**CITY OF DEXTER
PLANNING COMMISSION
WORK SESSION
MONDAY, MAY 4, 2015**

Re: 3441 Broad Street Special Use Review, plan dated May 4, 2015
Alternative plan A1.01alt and A1.01altB dated, May 27, 2015
Applicant: Craig Borum, Ply Architecture
Project: Strawberry Alarm Clock
Zoning: VR Village Residential

Re: 3441 Broad Street Combined Site Plan Review, plan dated May 4, 2015
 Alternative plan A1.01alt and A1.01altB dated, May 27, 2015
 Applicant: Craig Borum, Ply Architecture
 Project: Strawberry Alarm Clock
 Zoning: VR Village Residential

Regarding: Strawberry Alarm Clock Café
Combined Site Plan - Review No. 1
OHM JN: 0130-15-1011

1 SITE PLAN alternate B

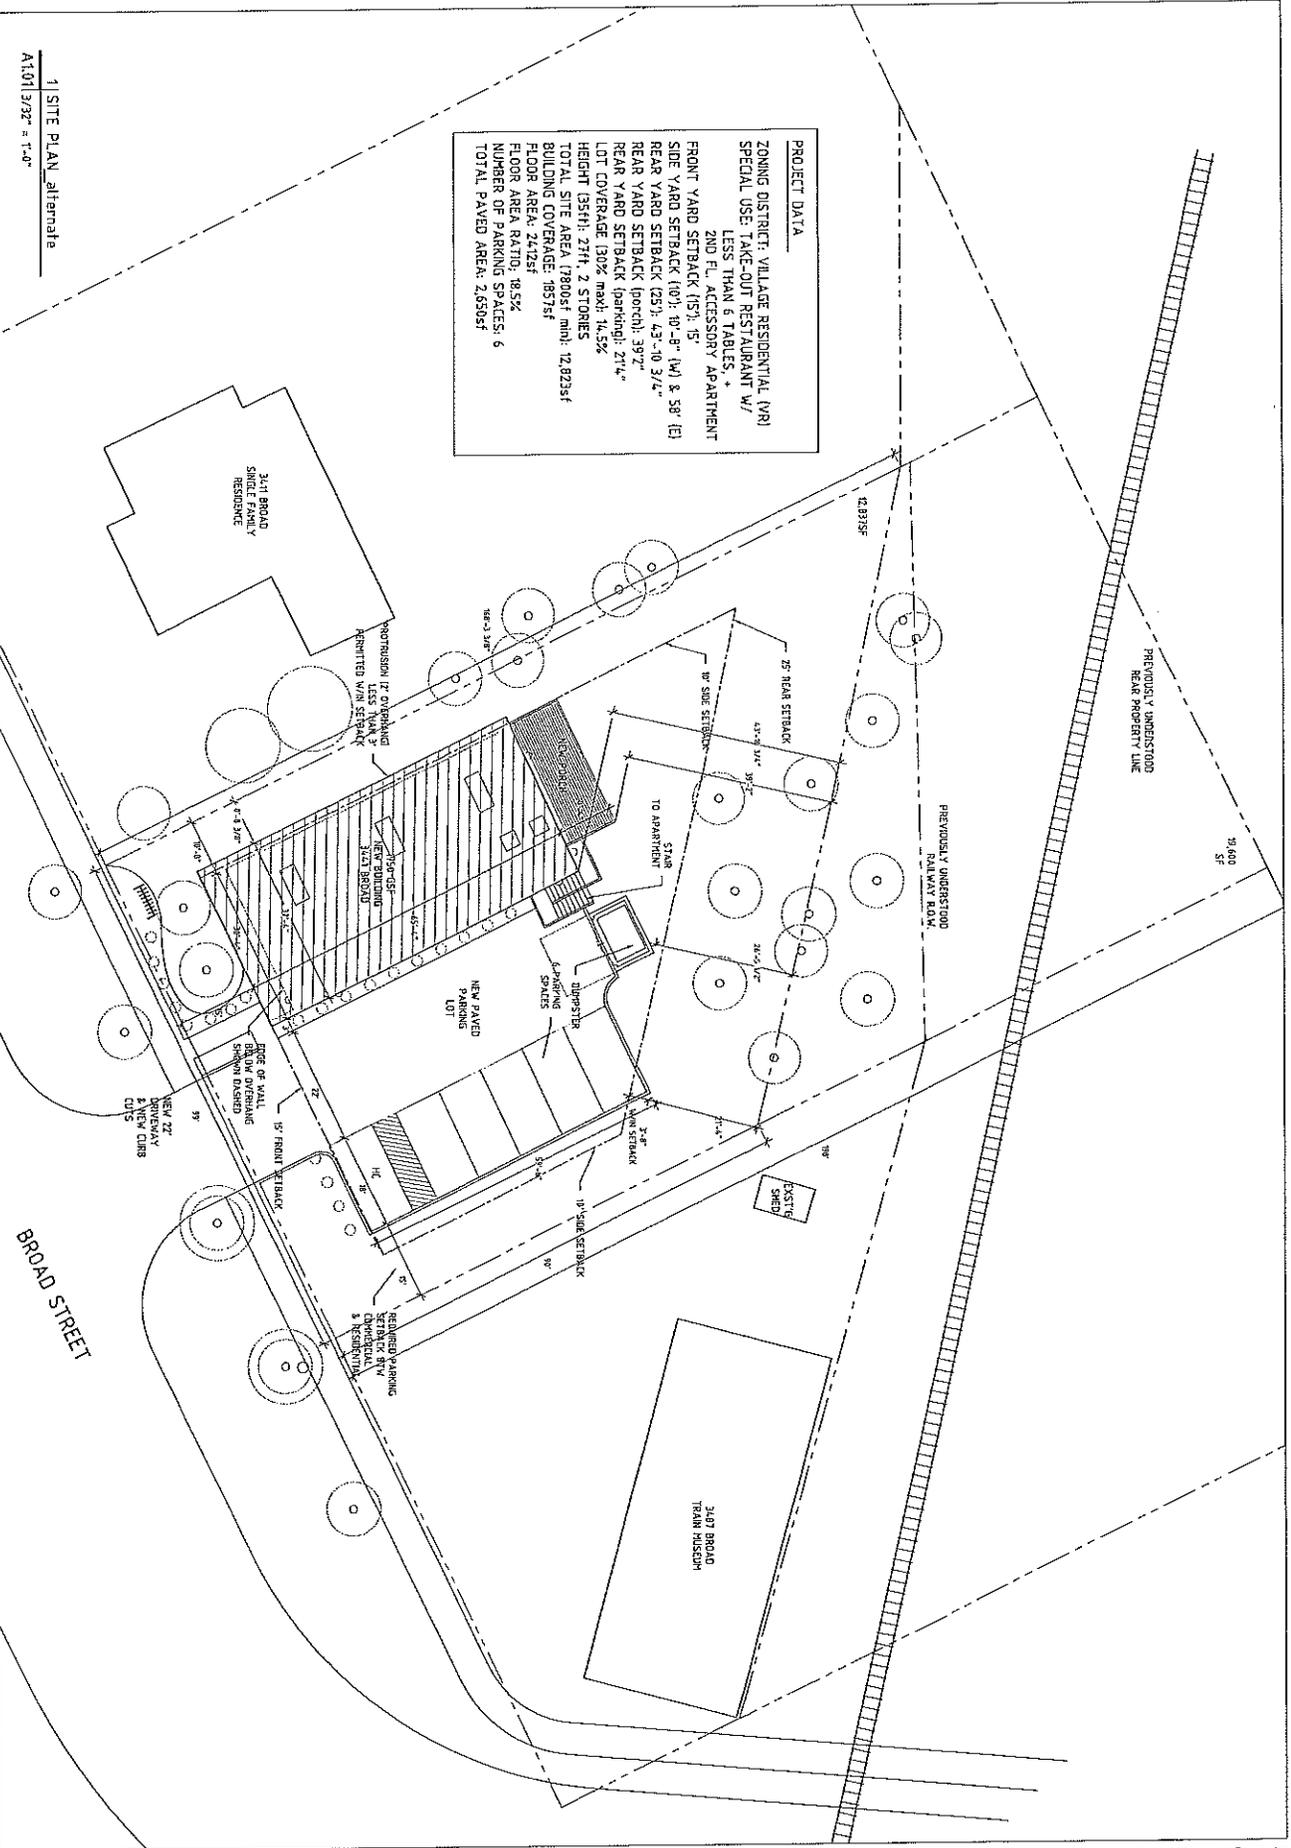
The applicant participated in two (2) pre-application meetings with the Pre-Application/Site Plan Review Committee, prior to submitting his request for special land use approval. A pre-application meeting allows a potential applicant to obtain information regarding the most optimum location of building(s) and other site improvements, prior to making formal application. Alternative 1.01B reflects the input received during the meetings.

The plan as revised complies with the required lot area, width, and coverage, building height, and front, side, and rear yard setbacks.

Based on the standards in Section 5.03, a maximum of 9 off-street parking spaces (8 regular and 1 barrier-free) are required. The revised plan provides 7 spaces, which includes 1 barrier-free space.

Staff recognizes that while necessary, off-street parking has the potential to change the existing character and scale of the subject site and surrounding neighborhood. Additionally, more parking means more impervious surface, which increase costs related to stormwater management. Staff encourages the Planning Commission to allow 7 off-street parking spaces.

If the planning Commission is prepared to take action on the proposed site plan and Alternative Sheet 1.01B, staff recommends the following conditions:

1. Review and Approval of the City Engineer regarding essential services;
2. Review and approval of the DAFD;
3. Deviation of the parking requirements to allow a total of 7 off-street parking spaces;
4. Information related to delivery vehicle type, timing, etc. to ensure site circulation will not be impacted during hours of operation must be provided;
5. The applicant must submit a revised landscape plan 1) that is signed and sealed by a State of Michigan licensed landscape architect and 2) provides the size of all plantings.
6. The maximum area of the wall sign shall not exceed 12 sq. ft.

1 PROPOSED SITE PLAN
A1.00 | 1/8" = 1'-0"

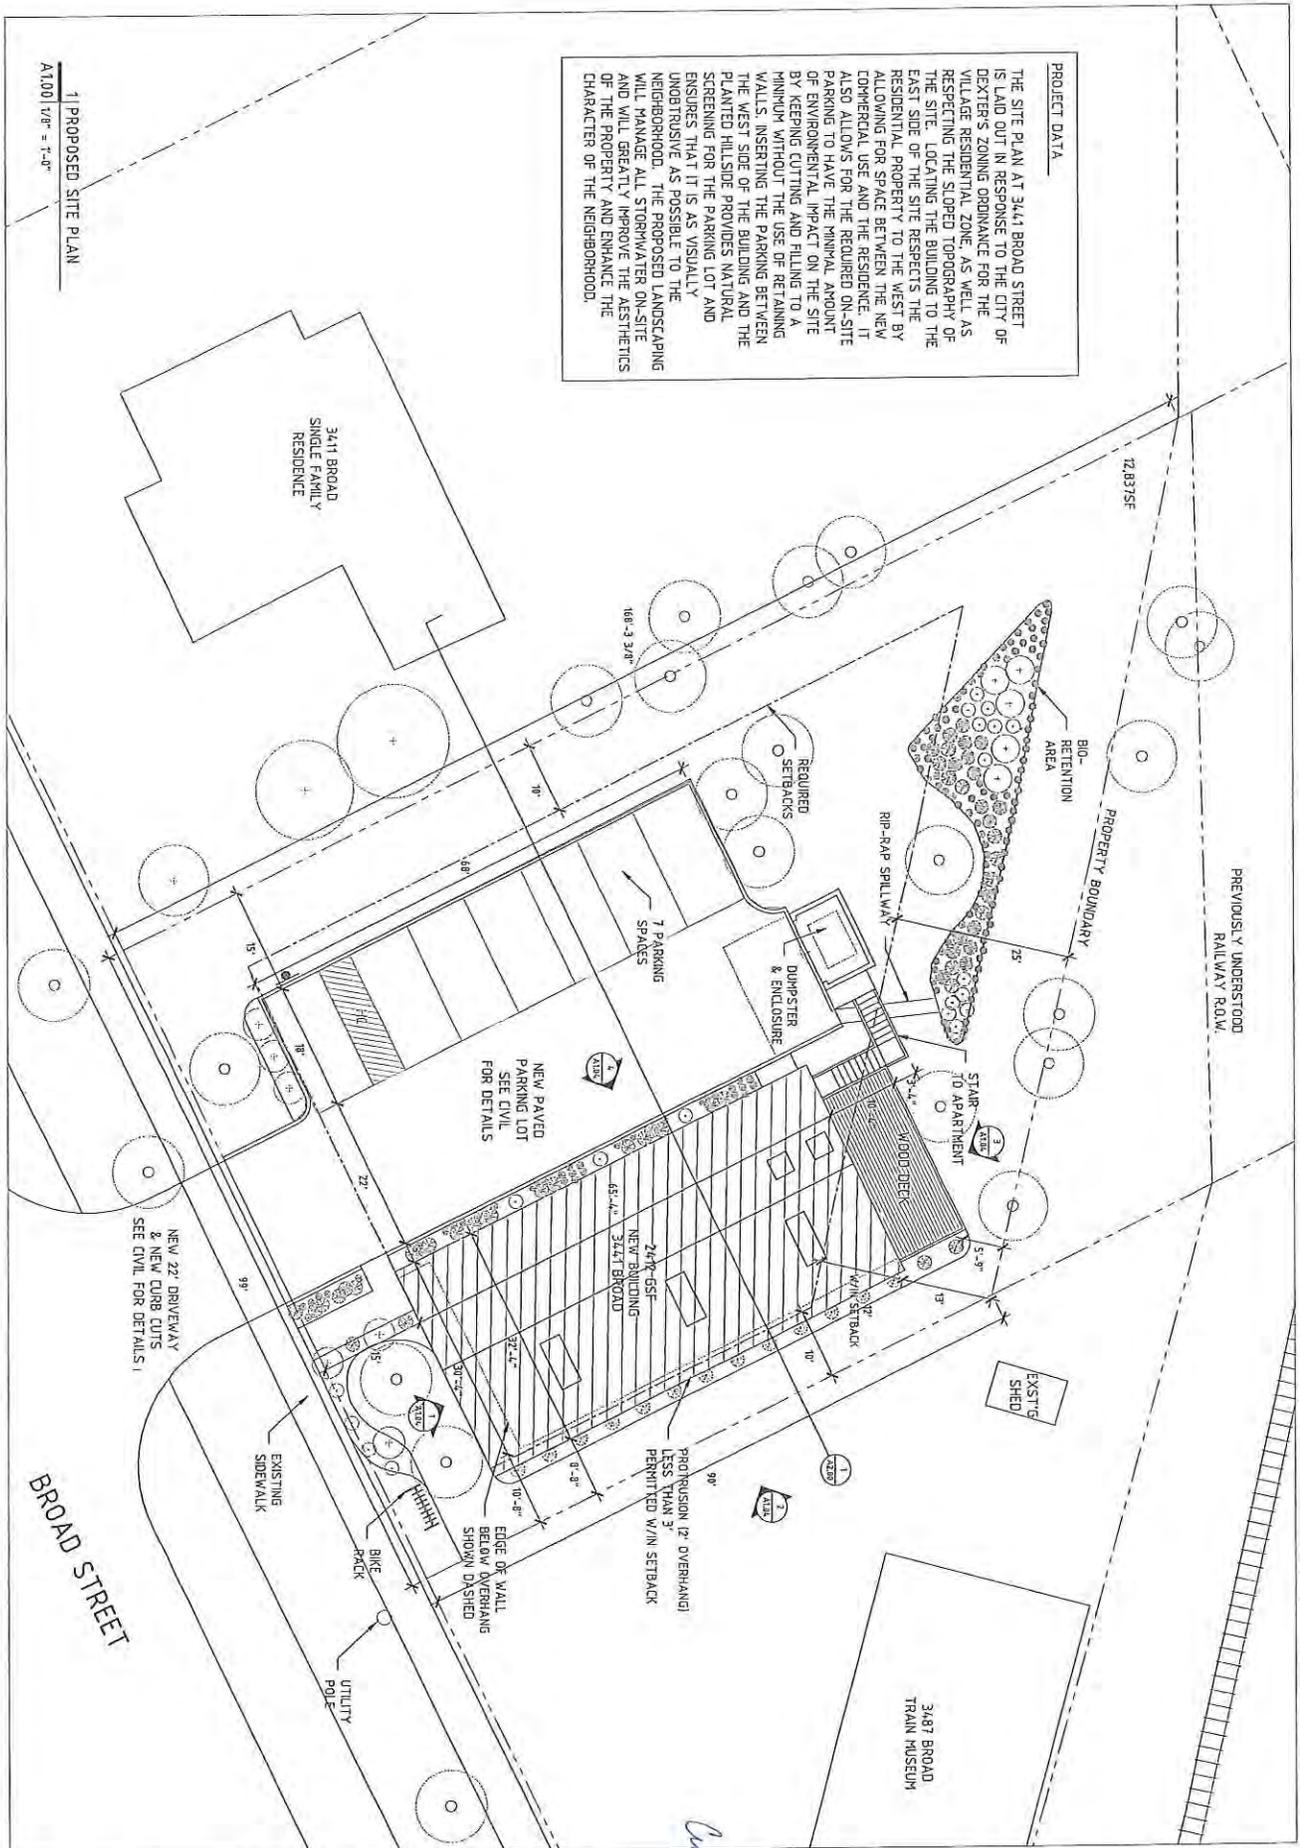
Items to be Addressed: Obtain a variance from the ZBA or provide an alternative design that will meet the required 25-foot rear yard setback.

As proposed, the site is deficient one (1) parking space. Section 5.01G. allows the Planning Commission to permit deviation from the requirements and may require more or allow less parking whenever it finds that such deviations are more likely to provide a sufficient number of parking spaces to accommodate the specific characteristics of the use in question.

Items to be Addressed: 1) Planning Commission to consider allowing a deviation in the parking requirements. 2) Provide information related to delivery vehicle type, timing, etc. to ensure site circulation will not be impacted during hours of operation.

PROPOSED LANDSCAPE PLAN

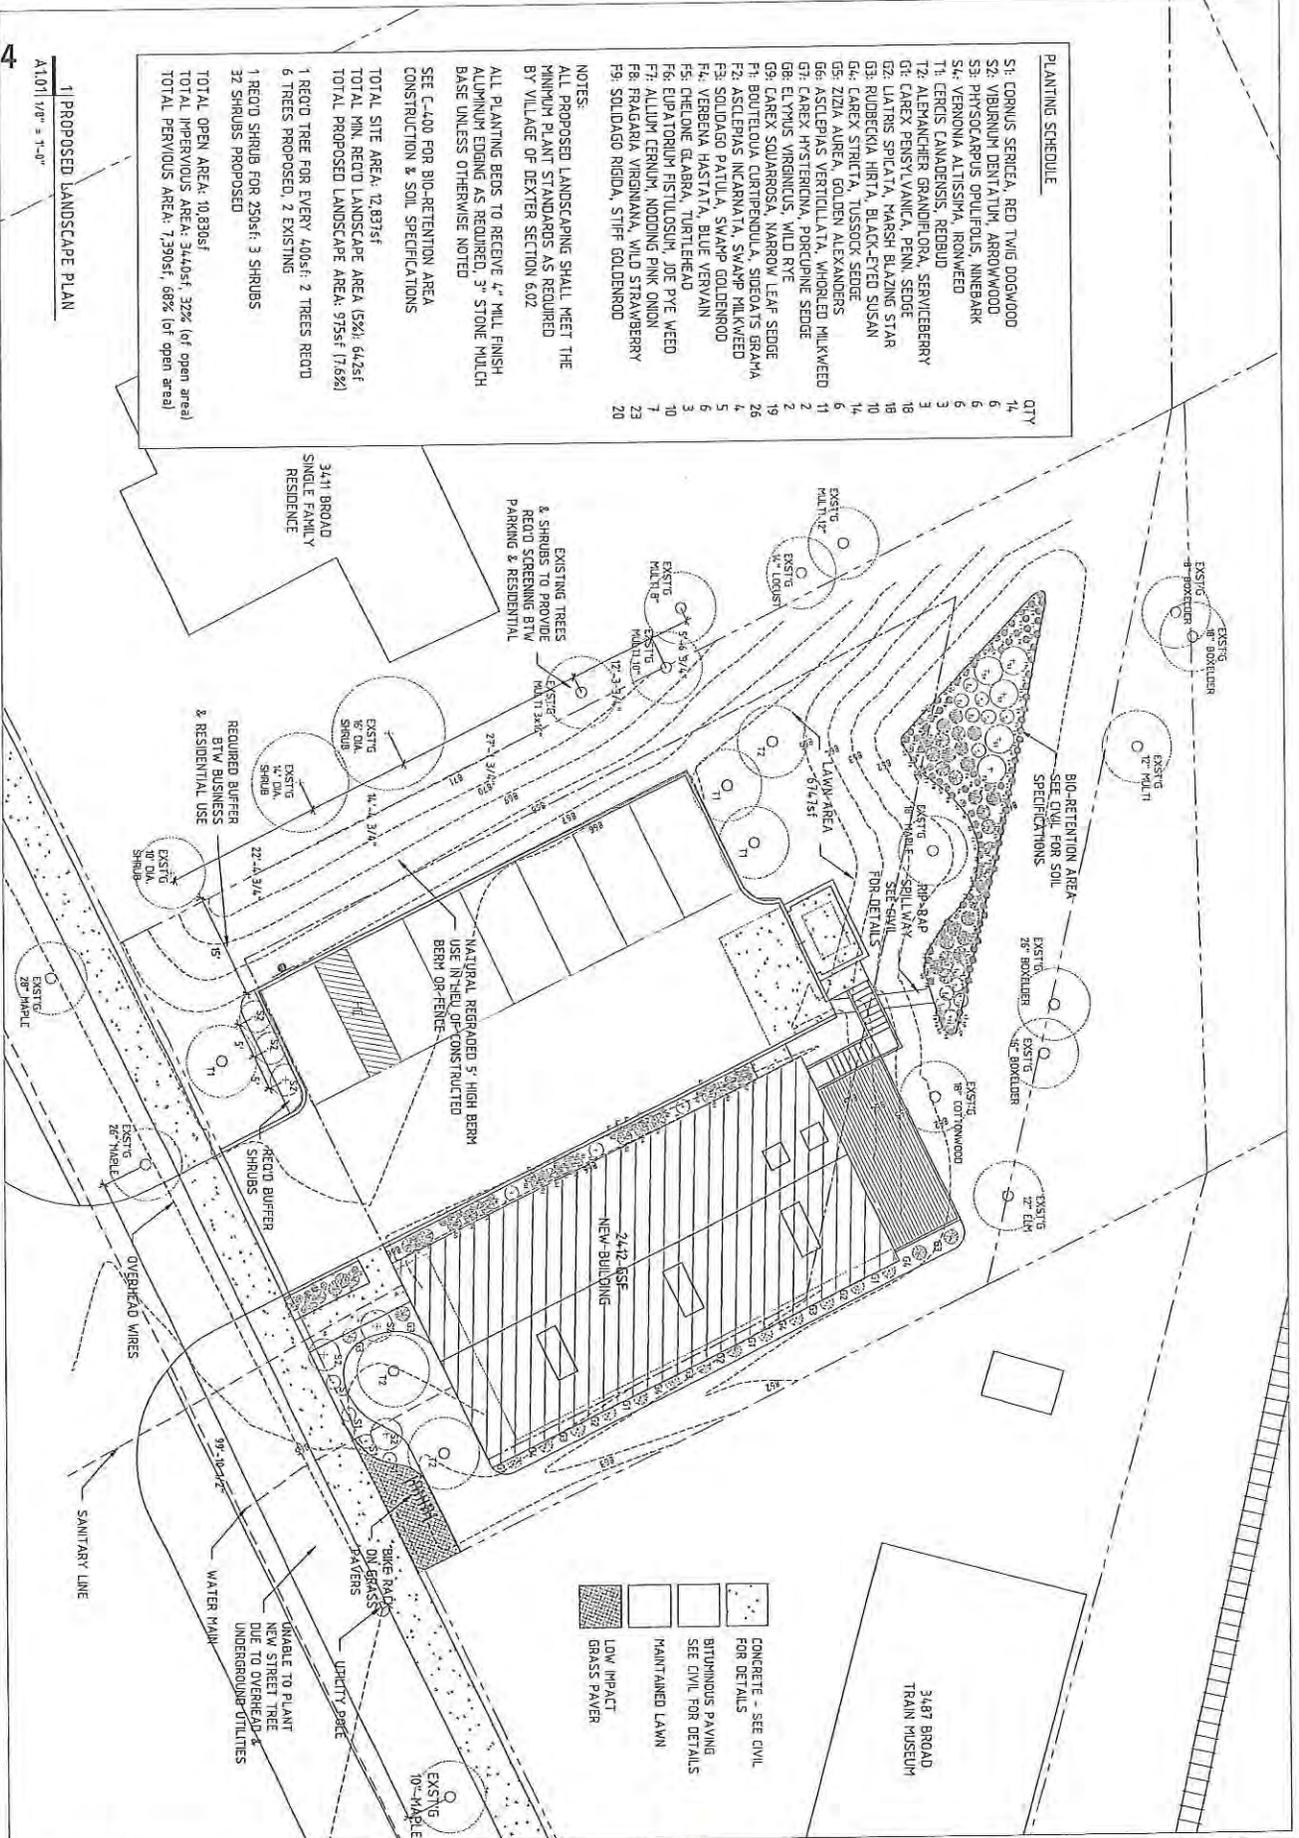
A landscape plan has been provided on a separate plan sheet (Sheet A1.00); however, it is not prepared and sealed by a landscape architect licensed in the State of Michigan (Section 6.12A.). The landscape plan contains the following information:

Composition – Section 6.02A. notes *no more than 25% of any one genus or 10% of any one species per site plan*. As presented on the Planting Schedule (Sheet A1.01), the composition of the proposed plantings appears adequate. However, the size of the proposed plantings has not been provided, and must be demonstrated on the planting schedule.

Items to be Addressed: 1) Landscape plan is required to be prepared and sealed by a State of Michigan licensed landscape architect. 2) Size of all proposed plantings must be provided. 3) Provide replacement trees as required in Section 6.14.

PROPOSED LIGHTING PLAN
A1.021 (VPR) = 1'-0"

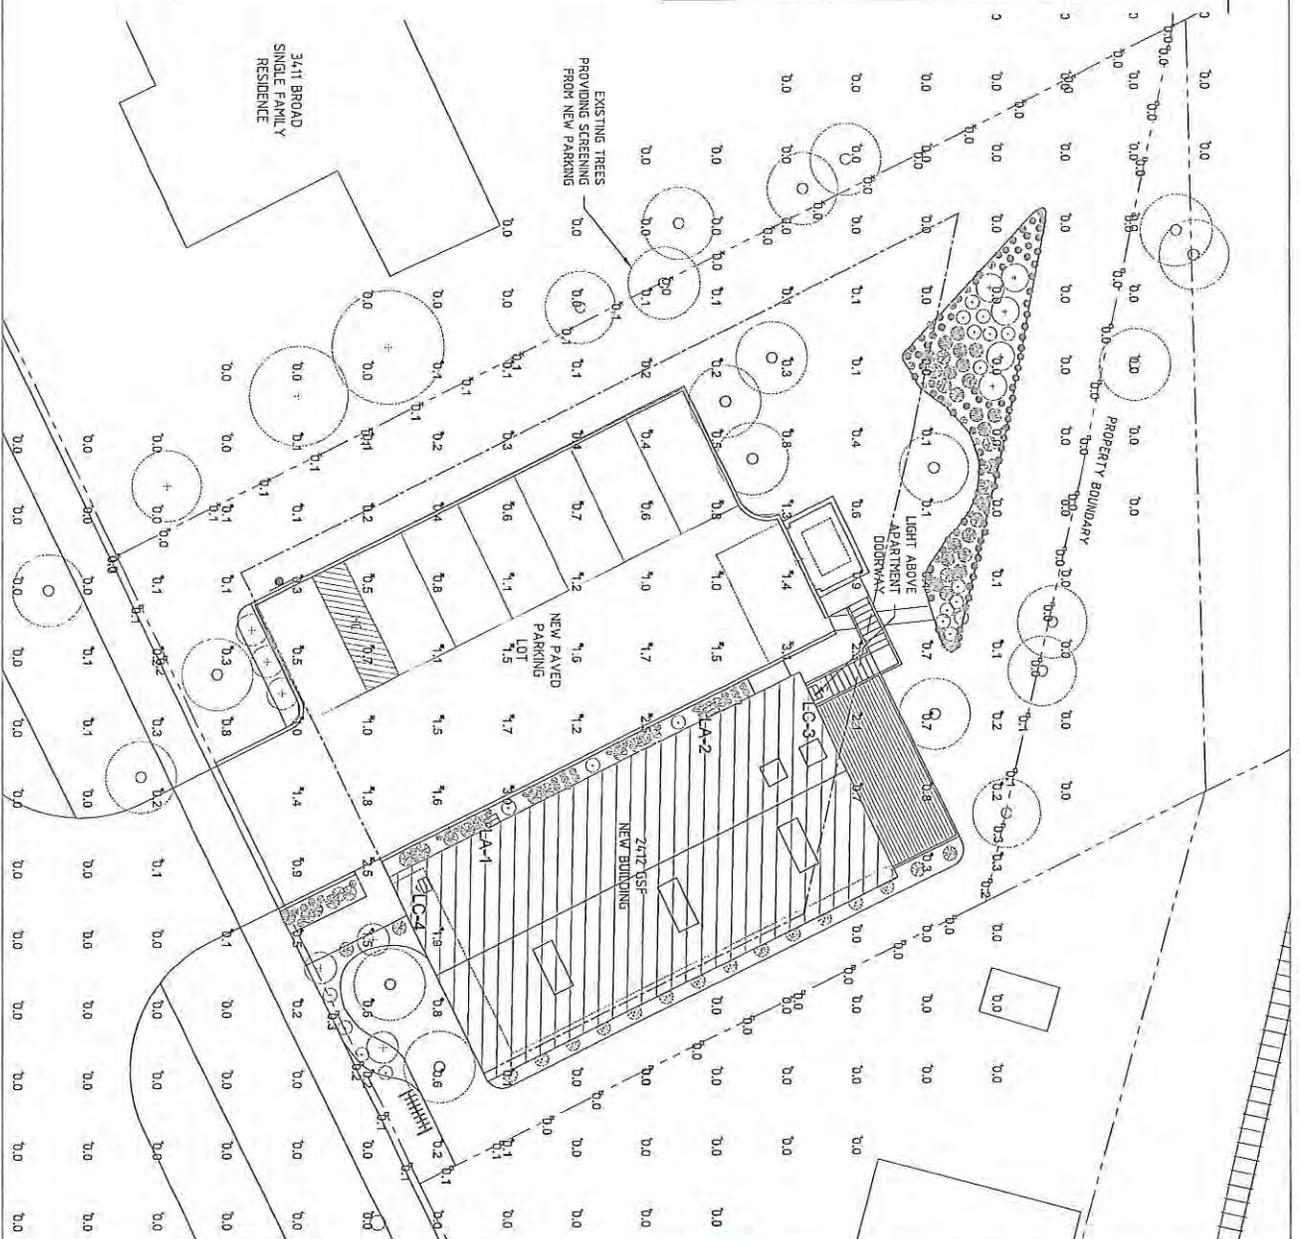
A lighting plan has been provided on Sheet A1.02. Four (4) wall mounted lights are proposed along the north, south and west building elevations. Detail of the proposed fixtures demonstrates they are downward directed, fully shielded fixtures. As presented, the proposed lighting fixtures meet all requirements of Section 3.19.
